Docket Nos. 50-282
and 50-306

The Commission has issued the enclosed Amendments Nos. ⁴⁹ and ⁴³ to Facility Operating Licenses Nos. DPR-42 and DPR-60 for the Prairie Island Nuclear Generating Plant, Unit Nos. 1 and 2, respectively. The amendments are in response to the matters listed below:

SAFETY EVALUATION BY THE OFFICE OF NUCLEAR REACTOR REGULATION
SUPPORTING AMENDMENT NOS. 49 AND 43 TO FACILITY LICENSE NOS. DPR-42 AND DPR-60
NORTHERN STATES POWER COMPANY
PRAIRIE ISLAND NUCLEAR GENERATING PLANT, UNIT NOS. 1 AND 2
DOCKET NOS. 50-282 AND 50-306

FIGURE TS.6.1-1 NSP CORPORATE ORGANIZATIONAL RELATIONSHIP TO ON-SITE OPERATING ORGANIZATION

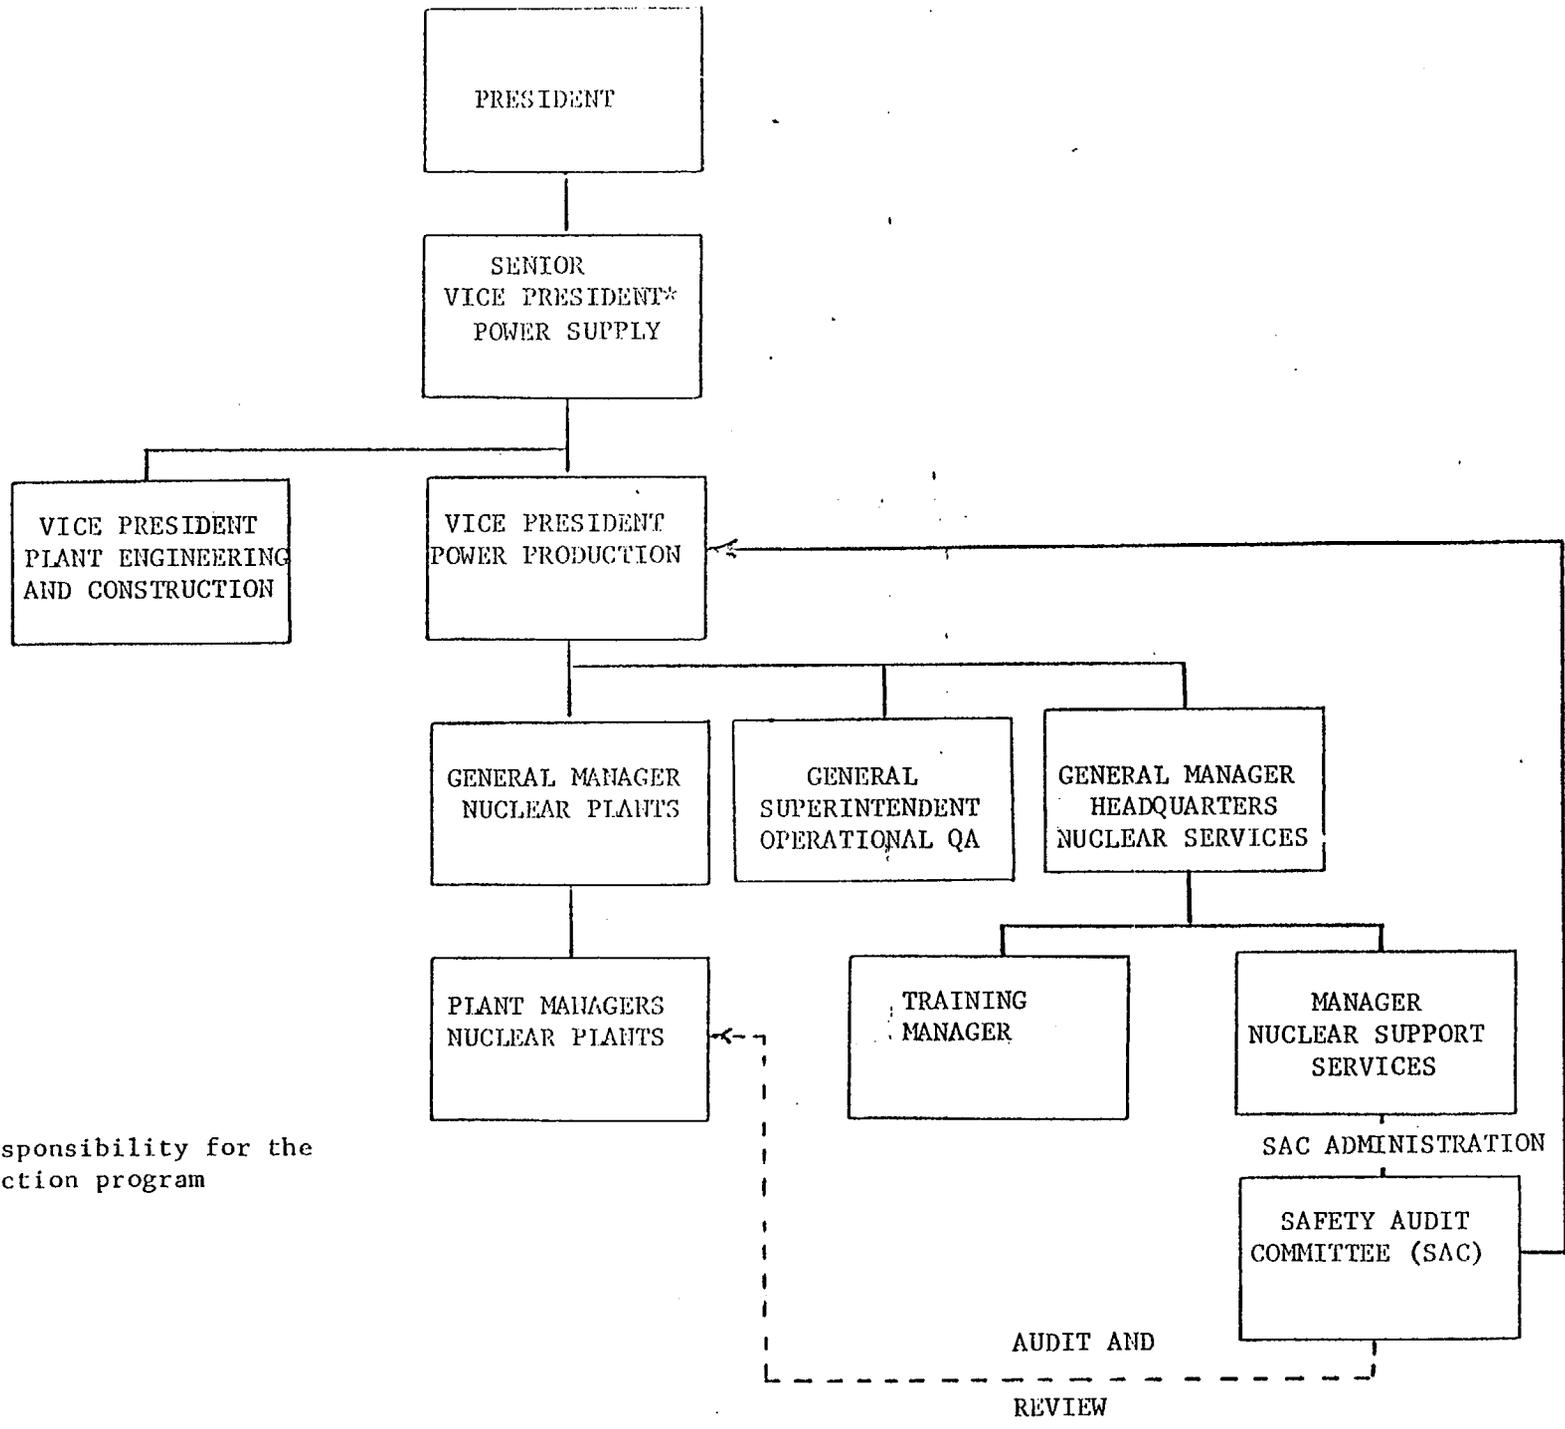
Item 8- The proposed change in the corporate organizational structure would replace the six management positions from the Plant Manager to the President with five positions, adds a management position for quality assurance activities to the organization chart, adds a separate position for the management of training activities and adds positions for the offsite nuclear support group.

FIGURE TS.6.1-2 PRAIRIE ISLAND NUCLEAR GENERATING PLANT FUNCTIONAL ORGANIZATION FOR ON-SITE GROUP

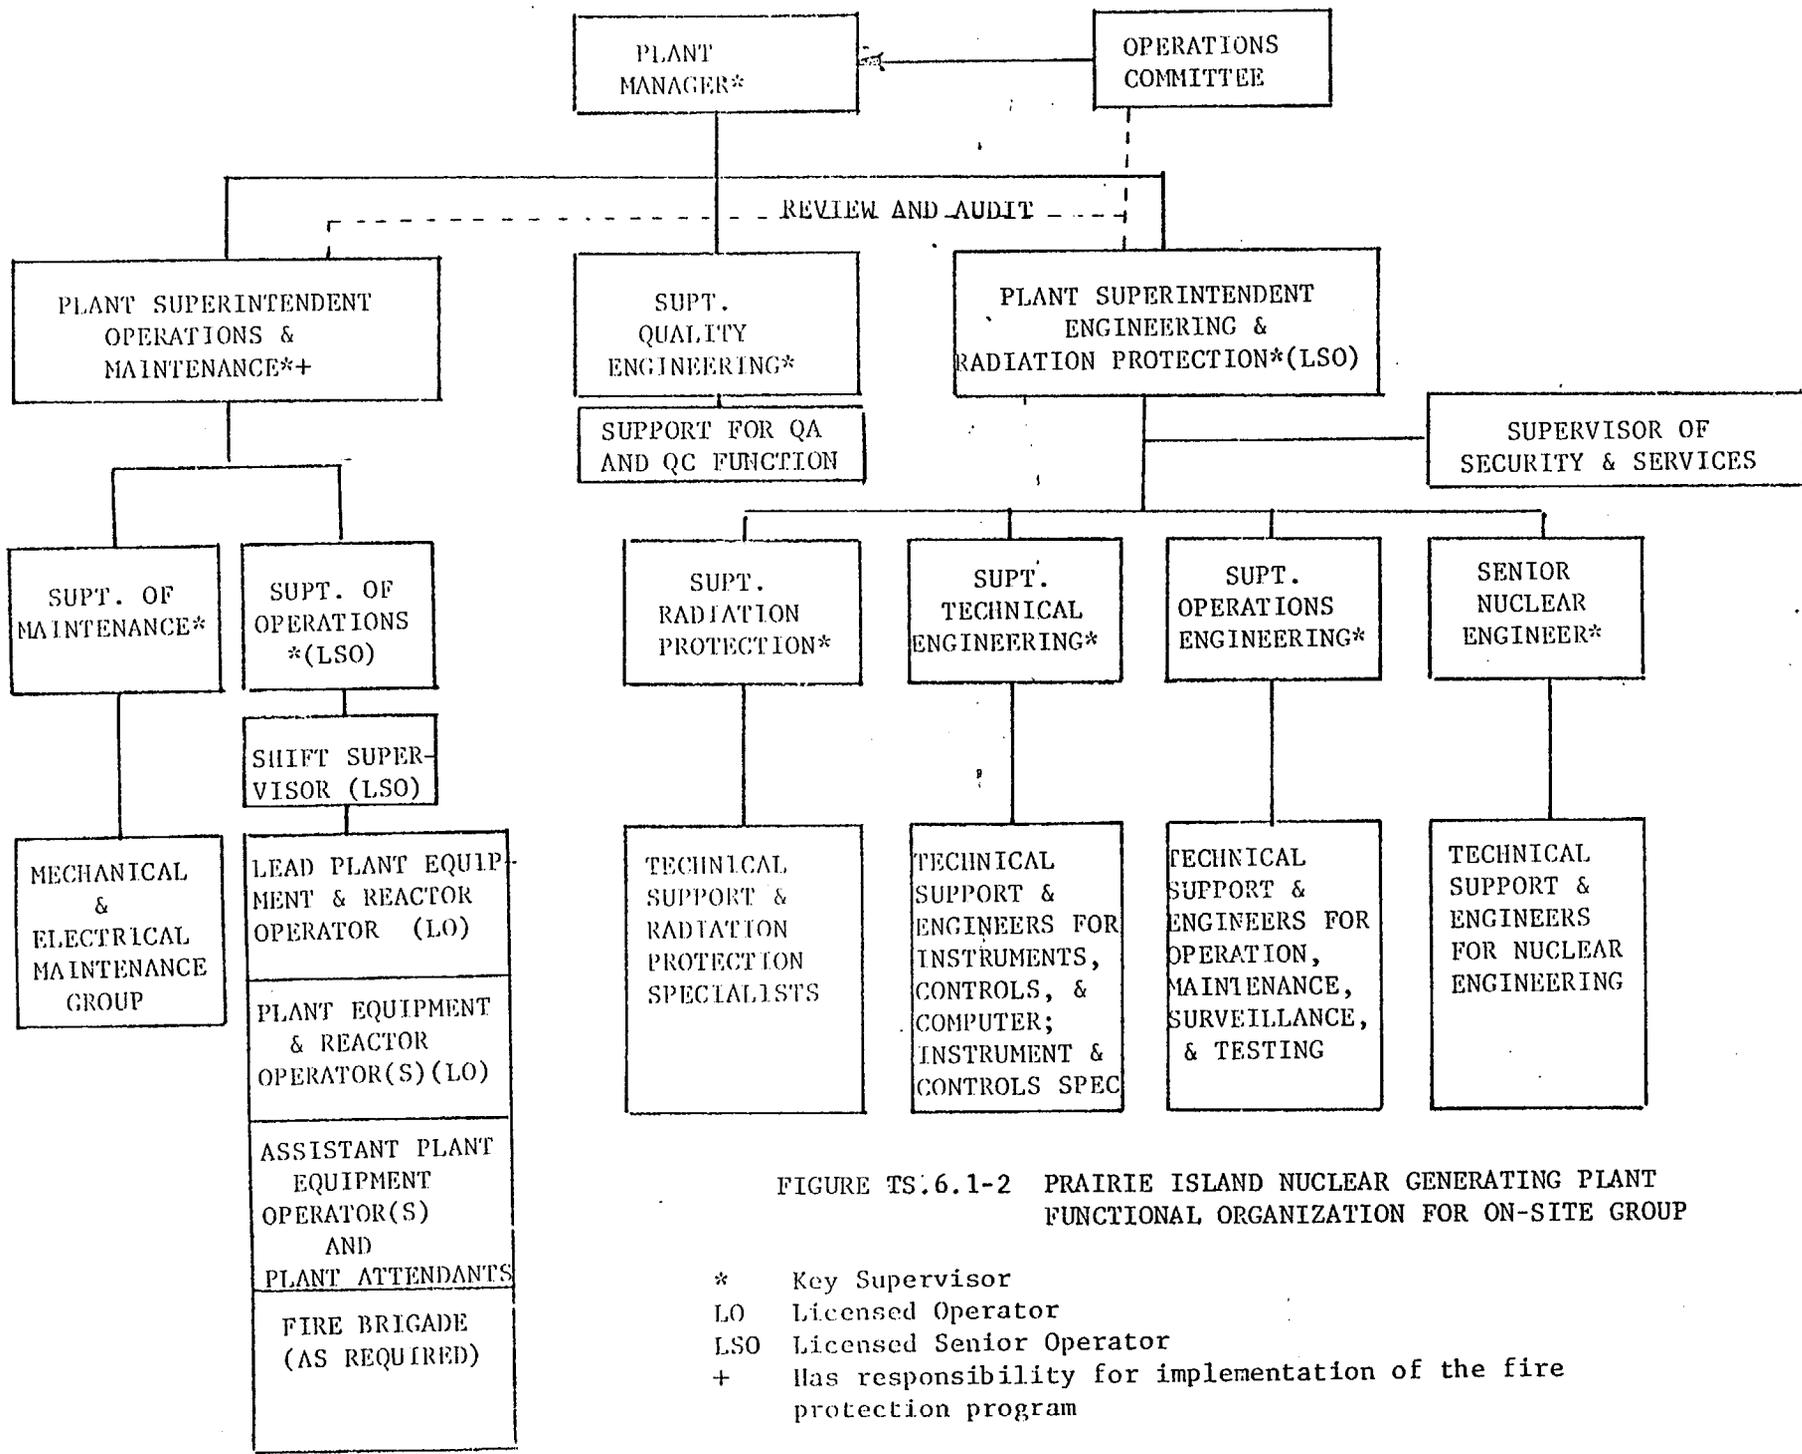
The proposed change in the on-site operating organization includes changing the Quality Engineer's position to Superintendent for Quality Engineering now reporting directly to the Plant Manager and other changes in titles for given positions which are otherwise unchanged.

Figure 2. Existing loss of voltage logic at Prairie Island Nuclear Generating Plant.

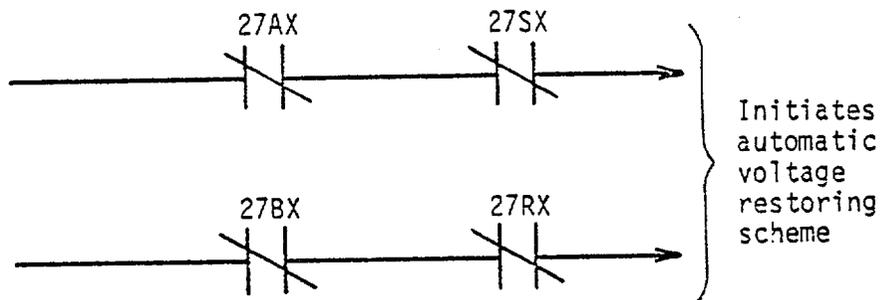
The present design uses undervoltage relays to sense the loss of offsite power. This design consists of four relays: two instantaneous acting and two time delay. The time relays are one second operate - one second release relays. The concept of this design is to reduce spurious operation both on voltage loss and voltage restoration. An undervoltage condition will result in isolating the Class 1E buses from all offsite sources, initiating emergency diesel generator start and load shedding on the Class 1E buses, and lastly, permitting closure of the emergency diesel generator supply breakers. Figures 1 and 2 indicate the existing design.

Figure 3. Modified bus 15 potential transformer circuit for Prairie Island Nuclear Generating Plant.

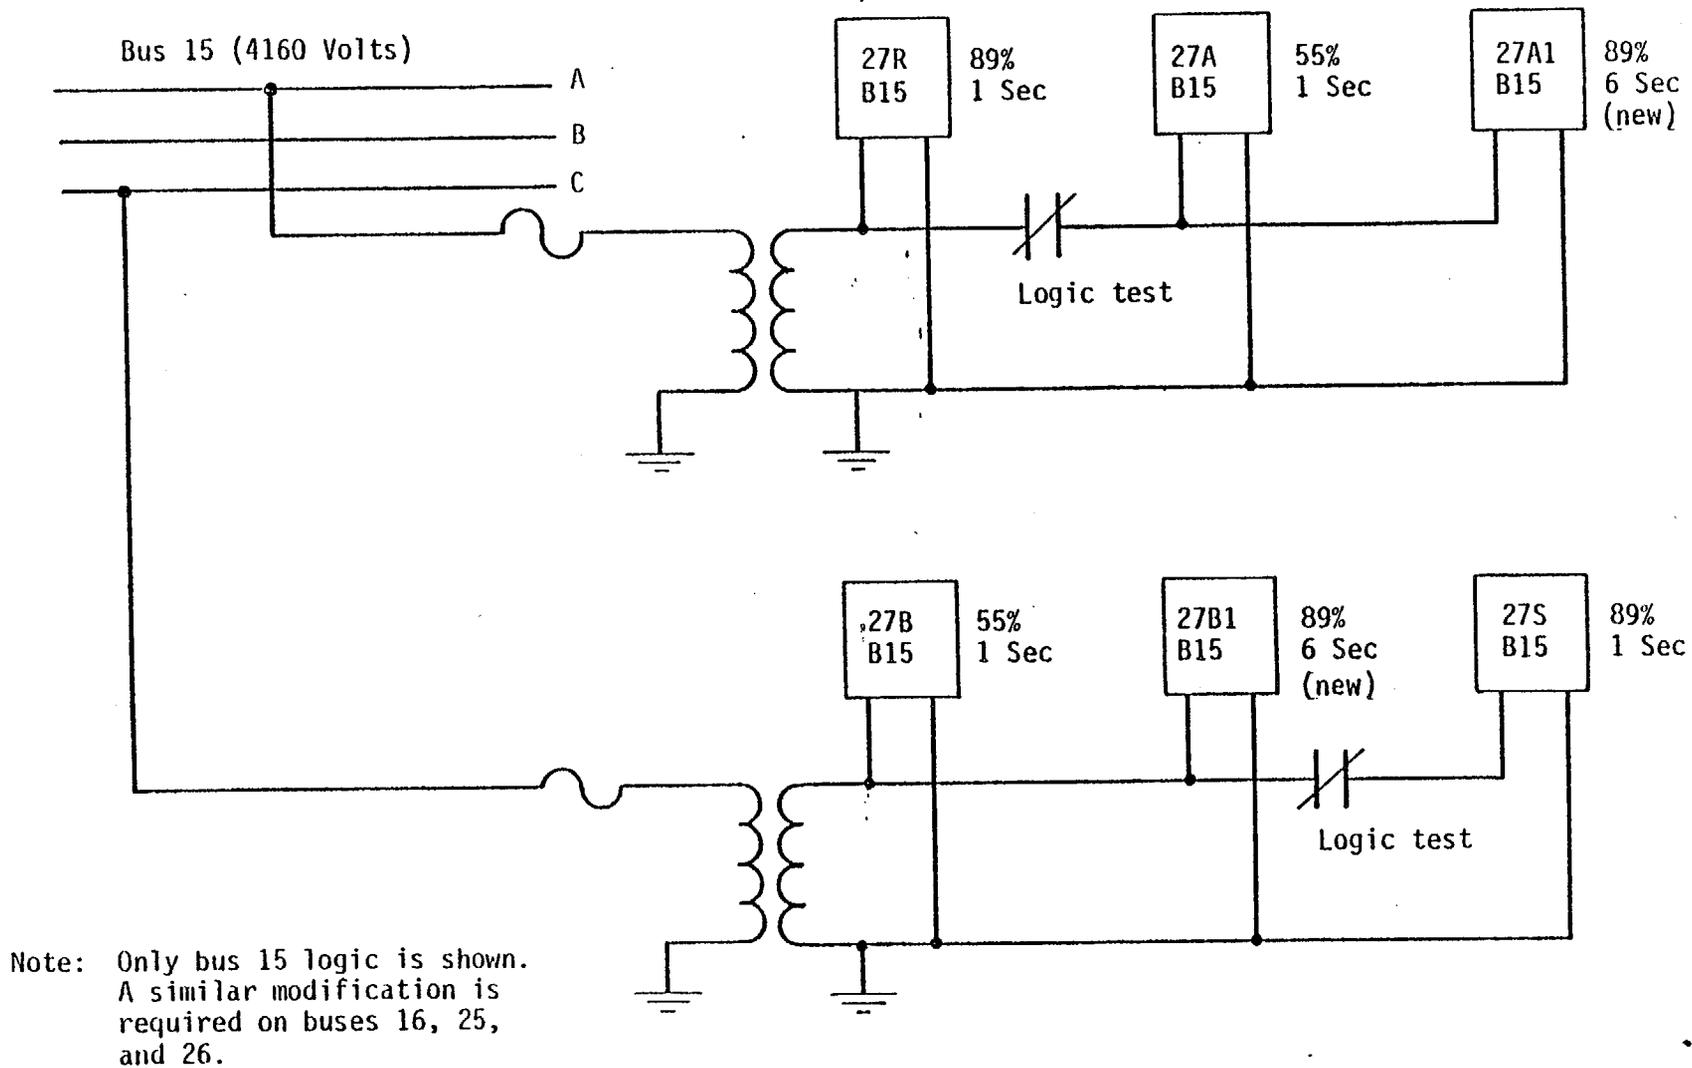
The licensee has proposed a design change which includes automatic degraded voltage protection. This modification consists of the addition of two time-delayed, undervoltage relays on each 4160-volt Class 1E bus. Also, the licensee will make circuit design changes to prevent load shedding when the Class 1E buses are being powered by the diesel generators, and will reinstate this load-shedding feature if the diesel generator breaker trips. The limiting conditions for operation and surveillance requirements for the proposed design changes as presented in this evaluation are documented in the licensee's proposed Technical Specifications.

voltage restoring scheme. The time for this relay dropout is inversely related to voltage taking 1 second at the 55 percent (+5 percent) voltage level down to nearly instantaneous operation at zero volts. This same logic will be used on all four of the Class 1E emergency buses.

Accordingly, we recommend that the NRC approve the proposed design modifications and Technical Specifications.
